PUBLICATION UPDATE BULLETIN

This PUB: 741-1190-4

This PUB contains adjustment/alignment procedures for the half height floppy drive part number 278-4033.

TITLE: 725-5083-VG and 725-5083 floppy drive PCB layout change

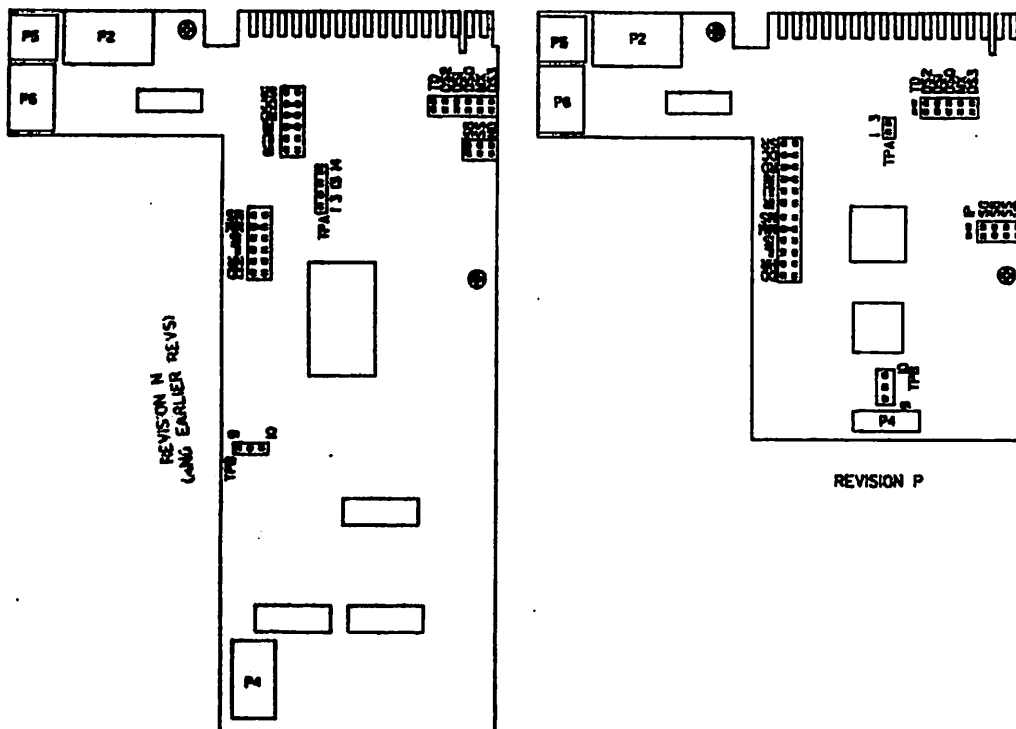
To inform the field of a change to the PC board layout on the Mitsubishi, model # MF504C-327UW, 725-5083-VG and 725-5083 5 1/4" 1.2Mb floppy disk drive.

Mitsubishi has changed their PC board layout, but there have not been any jumper changes involved in this design change. However, the location of the jumper headers has been altered per the following diagram. There are no labels to designate the change. A Mitsubishi revision level of "P" incorporates this new board design.

Modification from ~~725-0232~~ ^{or} 725-0258 to AT COMPATIBLE
V5/2200 To AT COMPATIBLE

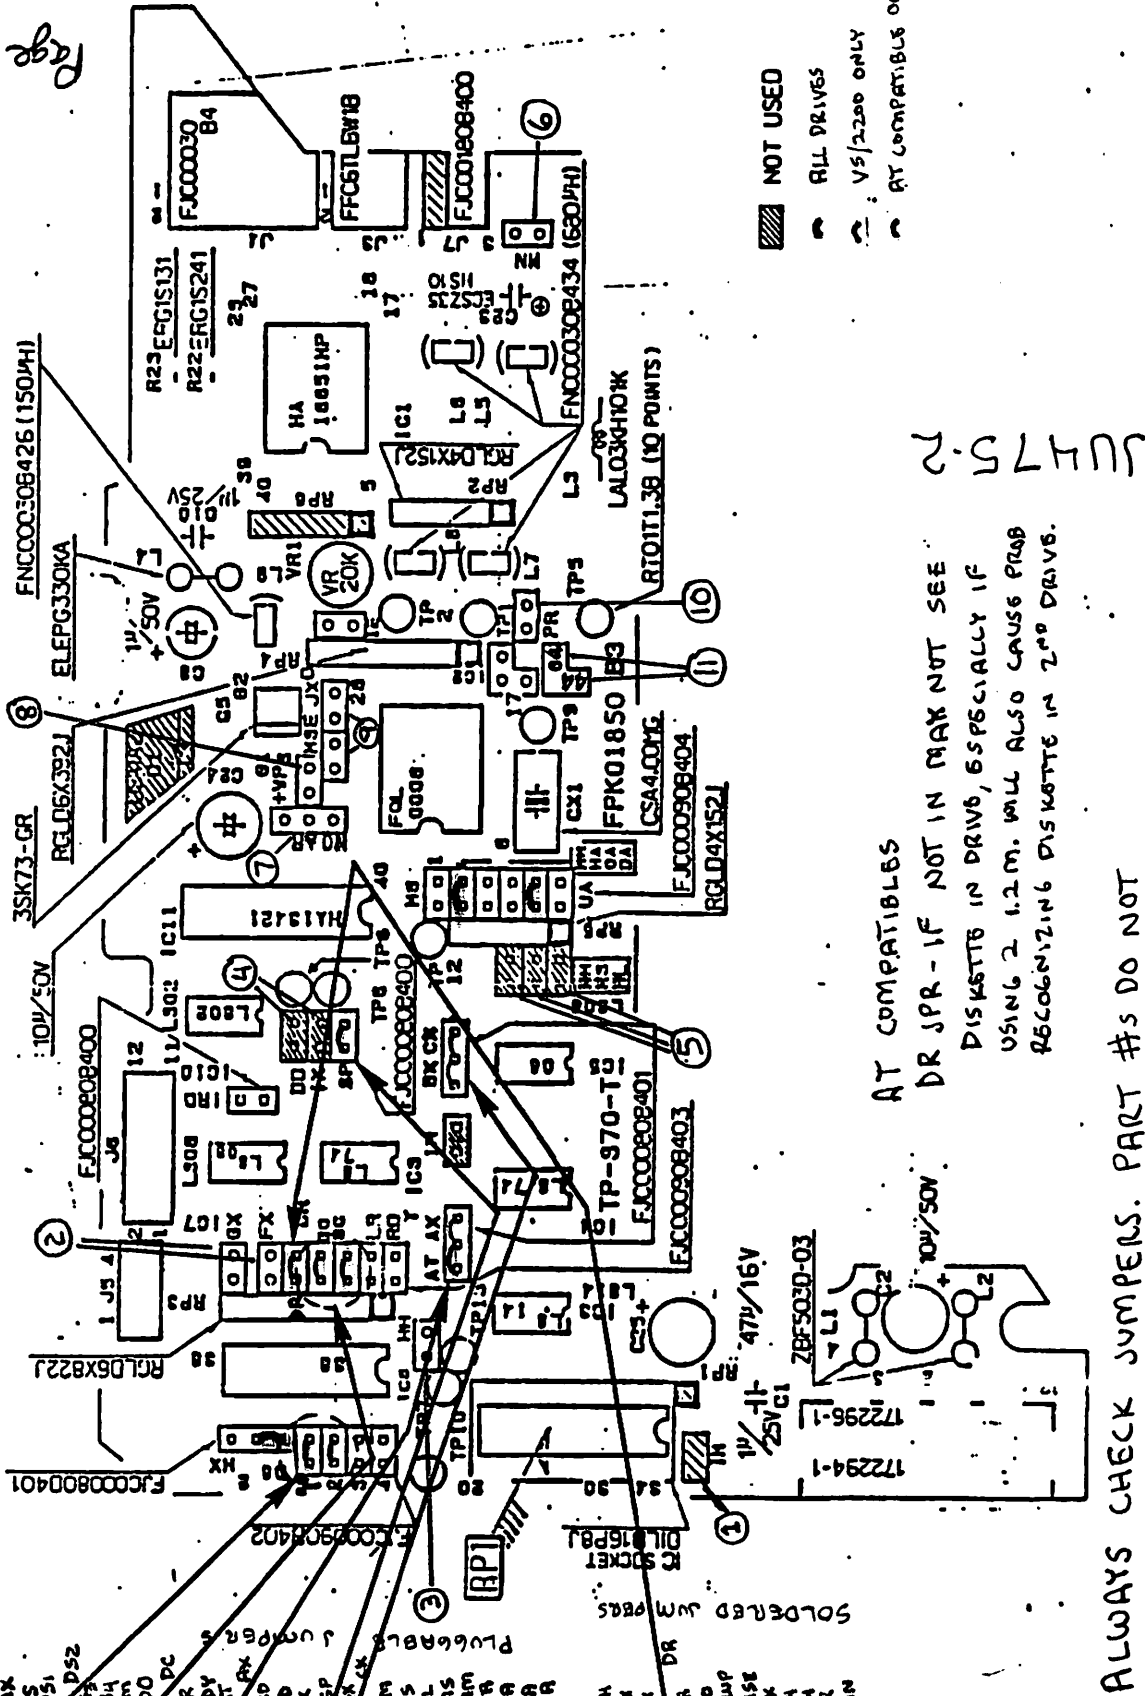
- 1) Move jumper from "DS 1" to "DS 2"
- 2) Install "DR" jumper
- 3) Install "SP" jumper
- 4) Remove "DO" jumper/install "DC" jumper
- 5) Remove "AX" jumper/install "AT" jumper
- 6) Remove "EX" jumper/install "CX" jumper

- 1) Move jumper from "DS 2" to "DS 1"
- 2) Remove "DR" jumper
- 3) Remove "SP" jumper
- 4) Remove "DC" jumper/install "DO" jumper
- 5) Remove "AT" jumper/install "AX" jumper
- 6) Remove "CX" jumper/install "BX" jumper
